AEBS/LDWS-02-02-Rev.1
100108

Addendum AEBS: Regulation No. AEBS+1

UNIFORM PROVISIONS CONCERNING THE APPROVAL OF MOTOR VEHICLES WITH REGARD TO THE ADVANCED EMERGENCY BRAKING SYSTEM

AEBS/LDWS-TF02-03-Rev.2

Consideration of document AEBS/LDWS-03-05 (J):

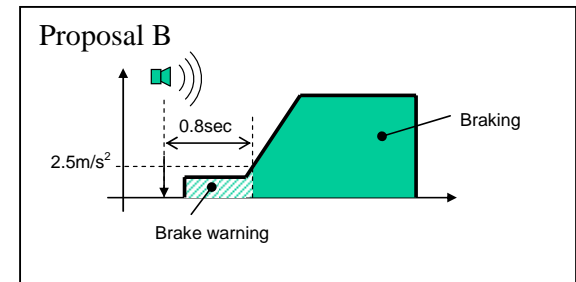
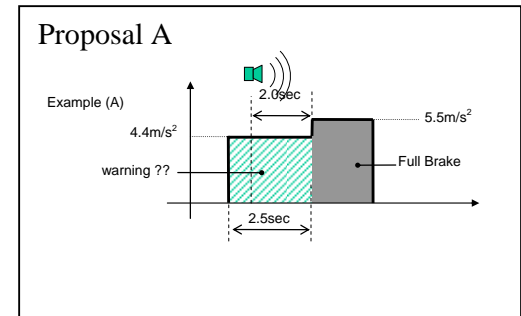
- **Proposal A** (“6.6.3.3. ... provide warning at latest 2sec. before full braking”):
 - OICA / CLEPA: the example given can indeed be designed according to the current text of the skeleton paper, yet no manufacturer would offer such system contradictory to the spirit of safety. In addition, no regulation can prevent a manufacturer to design not appropriate systems. A regulation has rather the task of ensuring that the system is fitted, and that it functions.

- CLEPA:
 - 4.4 m/s² cannot be considered as a haptic warning, hence this shows that some limits must be found.
 - Timing is a parameter easy to catch from the CAN bus, as AEBS is a “Complex System”.

- OICA:
 - A high deceleration cannot be considered as a “haptic warning”, should have “small speed reduction” as a criterion.
 - As CAN interface is common practice between AEBS and braking system, suggestion to define 3 phases, and use the time of start of emergency braking, and speed reduction as reference parameters. Can be easily checked at the time of approval by reading the print-out of the the CAN signals after having performed the test.

- **Proposal B** (“6.6.3.3. ... provide warning at latest 0.8 sec prior to the activation of service brake system.” Brake warning is not included as activation of service brake system, It is permitted to warn the driver simultaneously of service brake application when the emergency situation such as when the system detects the sudden cut-in of a vehicle.

- OICA:
 - As the group agreed to separate the general requirements from the test requirements, there is no need to consider the case of a vehicle in all real situations

- There is indeed the need for a deceleration threshold
 - Value of 2.5 m/s² is questionable: ACC operation could mask the haptic warning.

- CLEPA: concerning the last OICA comment: the test procedure assumes that ACC is not in operation; matter of CEL annex.
- **Proposal C** (“6.6.3.3. ...Provide warning at latest 1 sec prior to deceleration, which is automatically applied by AEBS, reaches 4.0m/s²)
 - OICA: questioned the value of 1.0 second
 - CLEPA: concerned that the provisions would forbid emergency braking below 4 m/s².

Chair summary:

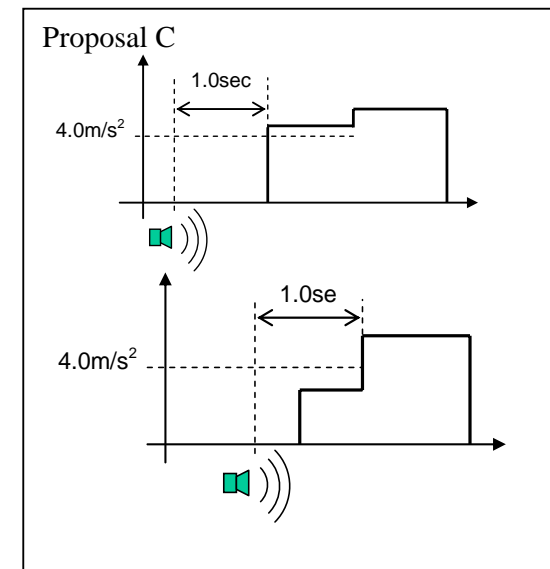
- Emergency braking phase is crucial phase
- Need to agree on a reference point (between emergency braking phase and preceding phases) from which other parameters (such as timing for warning) can be defined
- Criteria for any warning braking preceding the emergency braking phase may need to be specified
- Performance criterion for the emergency braking phase: either speed reduction or deceleration value.
- To maintain flexibility for the OEM to develop his haptic warning strategy, the performance requirements on haptic warning during the warning should be generic, e.g. by specifying a limit for the average speed reduction during the warning phase.

Some **informal discussions** led to the consideration of the situations that can be found in the logic schemes on page 45 (cases A to F).

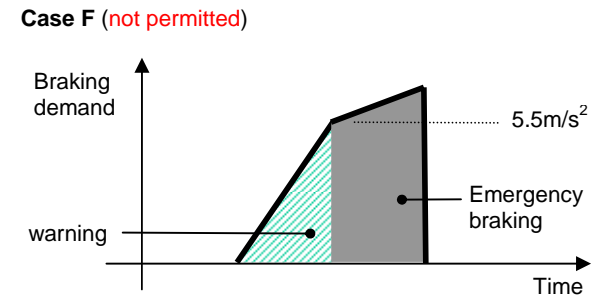
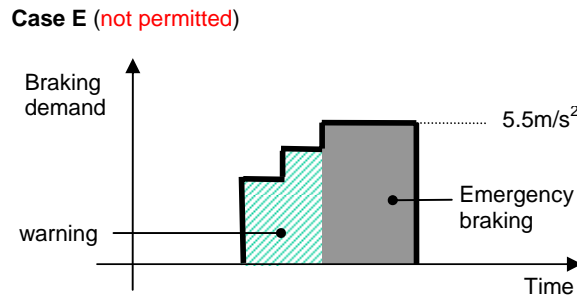
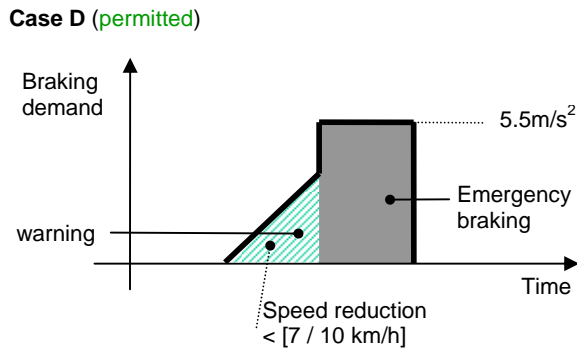
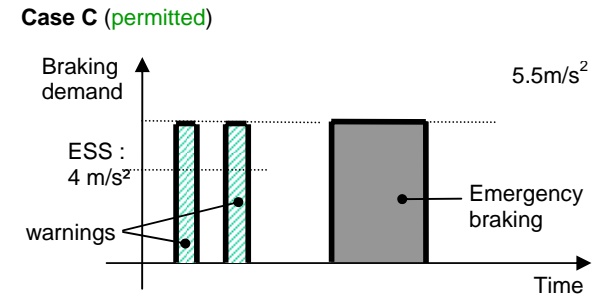
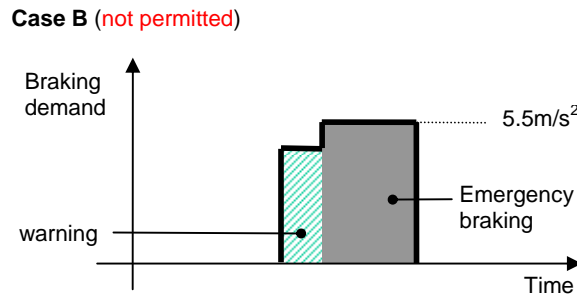
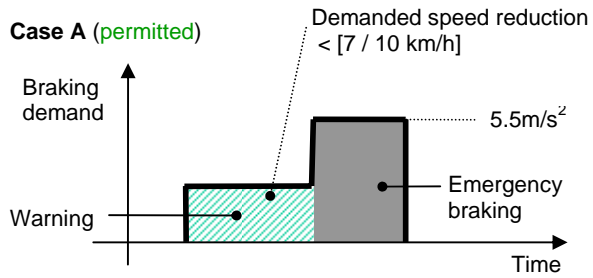
- Start of emergency braking taken as the reference point
- Warning by braking to be defined as being
 - below the emergency braking deceleration
 - above a certain minimum deceleration
 - before a certain delay to the reference point
 - of a longer duration than a certain minimum value.
- This implies defining a maximum speed reduction value and defining the shape of the shaded green surface in the logic schemes.
- Japan reluctant to generate the Emergency Stop Signal at the time of the warning; however recognizes the safety merits of early emergency stop lamp activation.

- OICA to provide information about the means to capture the CAN signals (feasibility of recording the braking demand), or any other logic signal commanding the ancillary systems (warning, braking, etc.) with the purpose of defining an approval procedure .
- All parties to build up a position toward the proposal :
“6.6.3.3. The AEBS shall warn the driver as mentioned in paragraph 5.5.1. at the latest [0.8 / 2.0] seconds before the emergency braking phase as defined in paragraph 2.XX. *If during this phase the AEBS applies the service braking, the speed reduction shall not exceed [7 / 10] km/h and the braking demand shall be [lower than in the emergency phase / below 4 m/s²]. [wording to avoid ESS activation]*”
- Japan to justify why to avoid the ESS generation during the warning phase.

- The braking phase
- The reference point
- The need to define requirements for the braking warning
